SOUTH BRYAN COUNTY SEWER FLOW DIVERSION TO RICHMOND HILL

J-27691.0057

ADDENDUM NO. 3

NOVEMBER 22, 2022

SHEET REVISION C2.2

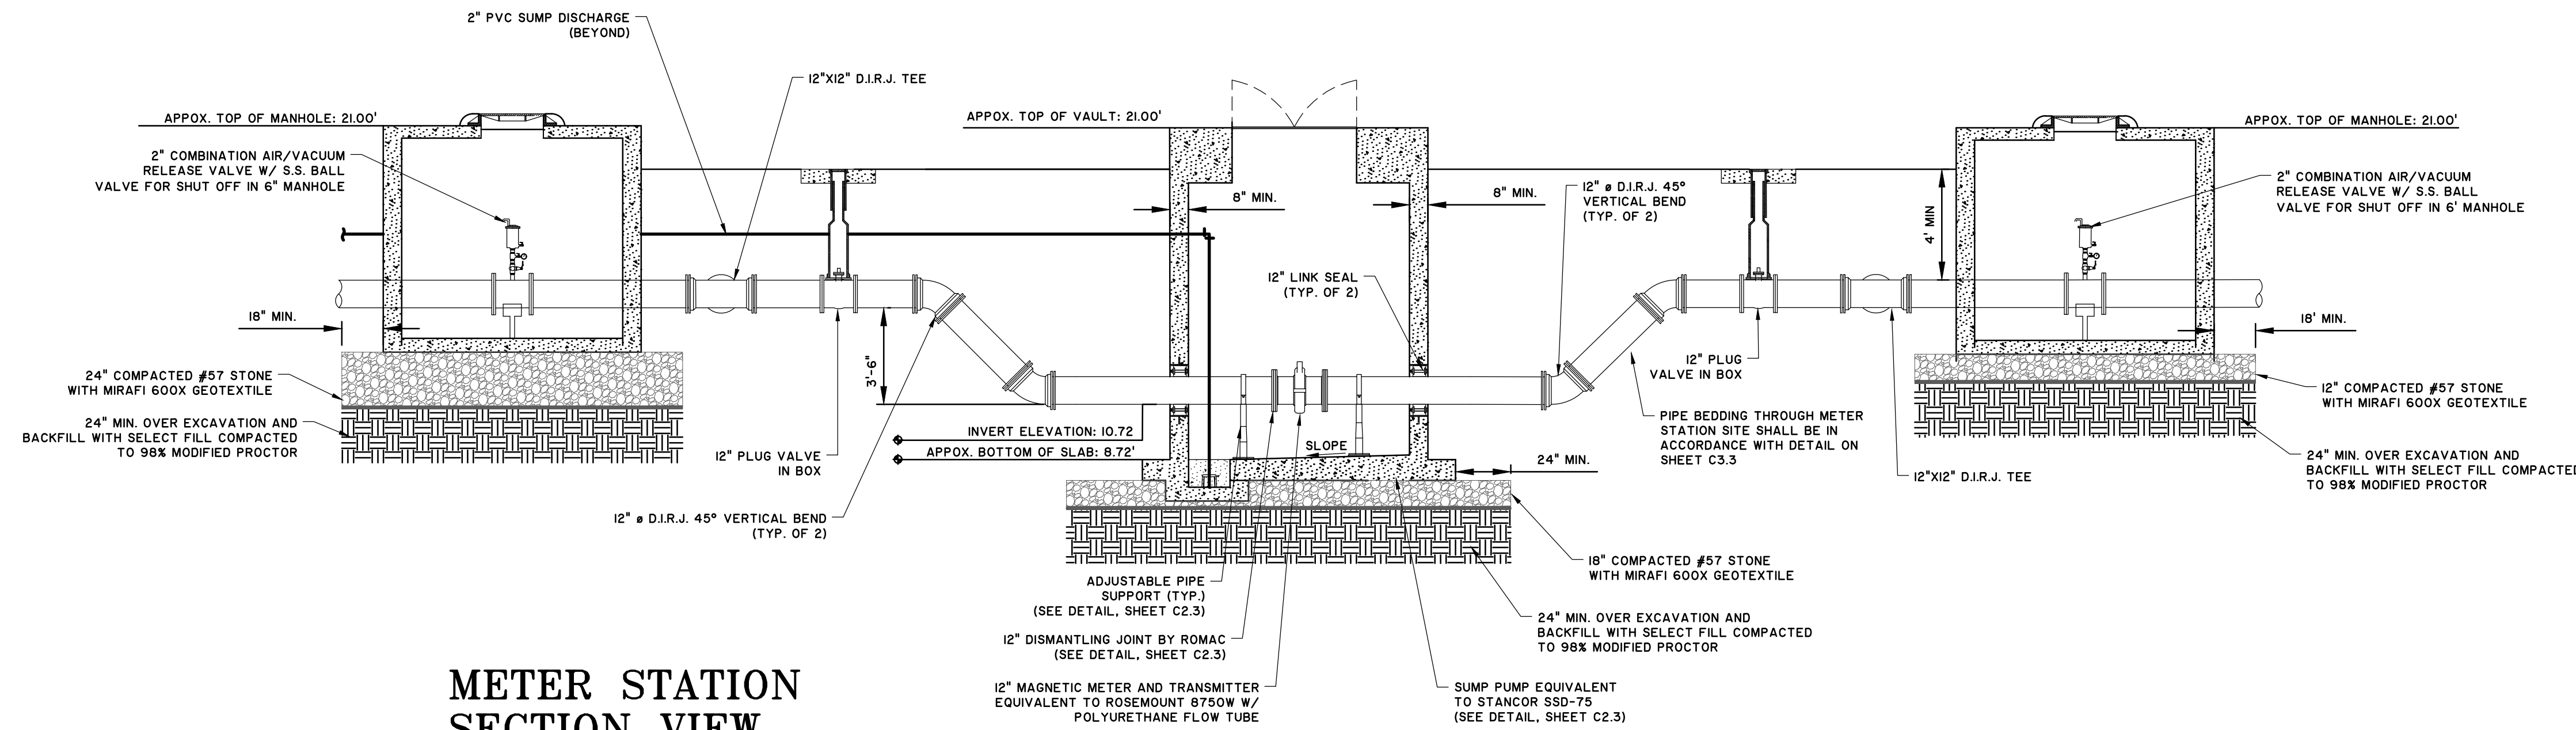
1. Question: Will there be interior coating of the meter vault?
Answer: Bituminous coating has been specified in the revised plan sheet and in revised Specification Section 02731 – Wastewater Collection System.

Revised Sheet C2.2 is attached to this Addendum. Note 15 under the “General Notes” text has been added to specify interior coating for the wet-well.
